DEPARTMENT OF PUBLIC WORKS  
COUNTY OF HUMBOLDT

LAND USE DIVISION INTEROFFICE MEMORANDUM

RE: SUBDIVISION REQUIREMENTS - IN THE MATTER OF THE  
APPLICATION OF BRIGHT VIEW HOMES LLC, APN 510-121-026, PLN-  
2023-18247 FMS APPROVAL OF A TENTATIVE MAP, CONSISTING OF 1.6  
ACRES INTO 7 LOTS

DATE: 08/08/2014  
10/08/2015 revised  
12/03/2015 revised by Planning Commission  
09/06/2023 revised by Public Works

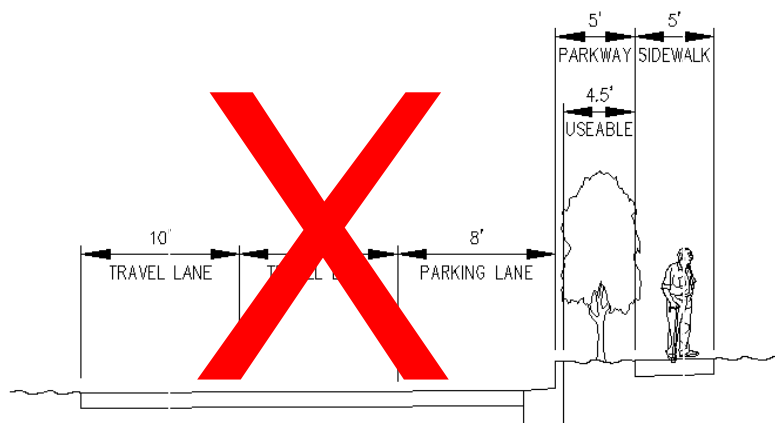
A stop sign will be required on Midtown Court at its intersection with Railroad Drive.

In addition, pursuant to County Code Section 323-2(c)(4), non-county maintained roads shall be posted with a sign of at least 2 square feet in size containing substantially the following words in 2" high black letters on a yellow background: "Not a County Maintained Road" or "Not a County Maintained Street". The sign shall be approved by the Department prior to installation.

~~*Above: Typical Section for Midtown Court*~~

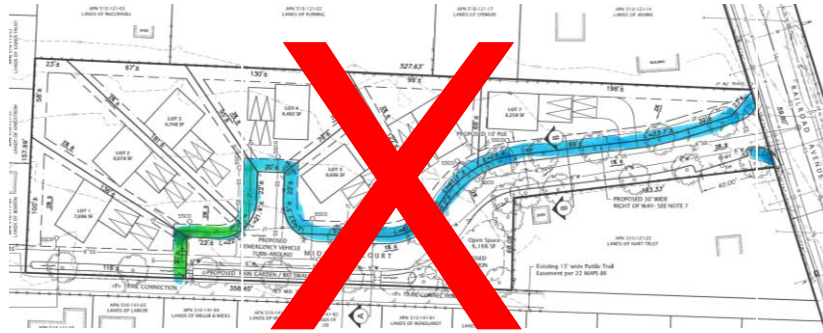
- (b) ~~**MIDTOWN COURT (Not County Maintained):** Midtown Court shall be constructed having a typical section comprised of two 10 foot wide travel lanes, an eight foot wide parking lane, a PCC Caltrans Type A1-6 curb [or APWA A3-150(6) curb], a 5 foot wide landscape strip (4.5 feet useable); and a 5 foot wide PCC sidewalk. The parking lane, landscape strip and sidewalk shall be located on the east side of the road. The sidewalk shall be constructed along the east side of the road from as shown on the tentative map ends at Lot 2; the sidewalk shall be extended to the southwest to connect to the Midtown Trail. The turn around and west side of the road shall be signed/stripped for "no parking".~~

~~The road is proposed to be cross sloped to the west to drain to the storm water detention basin. A Caltrans Type A2-6 PCC curb and gutter may be needed along the west side of the road from Railroad Drive (County Road No. 4M020) to the storm water detention basin.~~

**(b) MIDTOWN COURT (Not County Maintained):** Midtown Court shall be constructed having a typical section comprised of two 10 foot wide travel lanes. The road shall be widened to be 26 feet in width for the first 50 feet; then taper down to 20 feet. The road (including the turn around area) shall be signed/striped for "no parking". The road is proposed to have a tilt section.

*Above: Typical sections for Midtown Court (Alternate)*

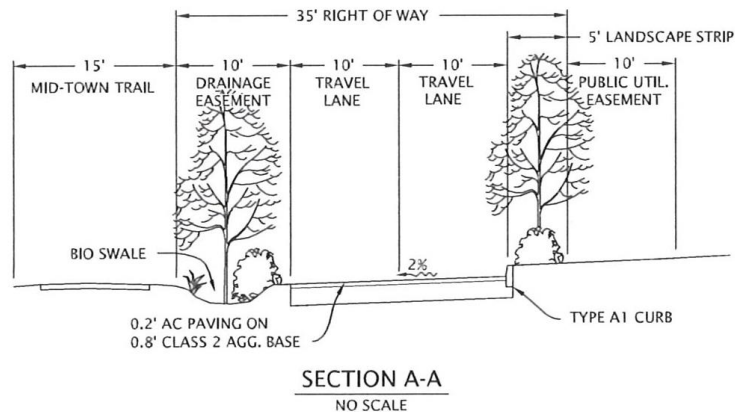
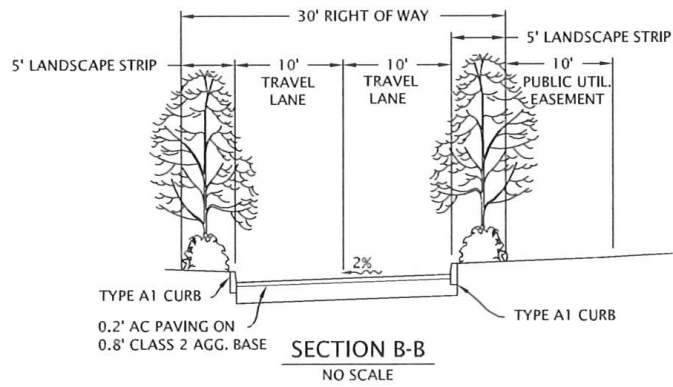
The road is proposed to be cross sloped to the west to drain to the storm water detention basin. A Caltrans Type A2-6 PCC curb and gutter may be needed along the west side of the road from Railroad Drive (County Road No. 4M020) to the storm water detention basin.

*Above: diagram showing the 26' wide road at the intersection of Railroad Drive*

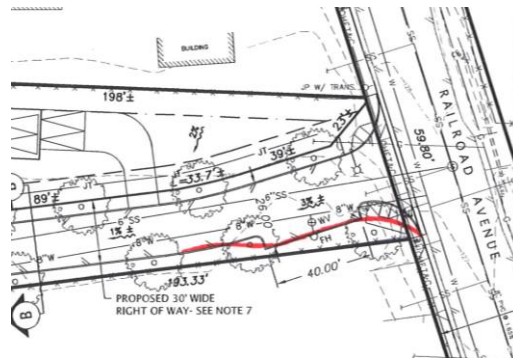
The applicant's agent has advised the Department that since no parking is to be provided, the A1 curb shown on the uphill side of the road may not be necessary.
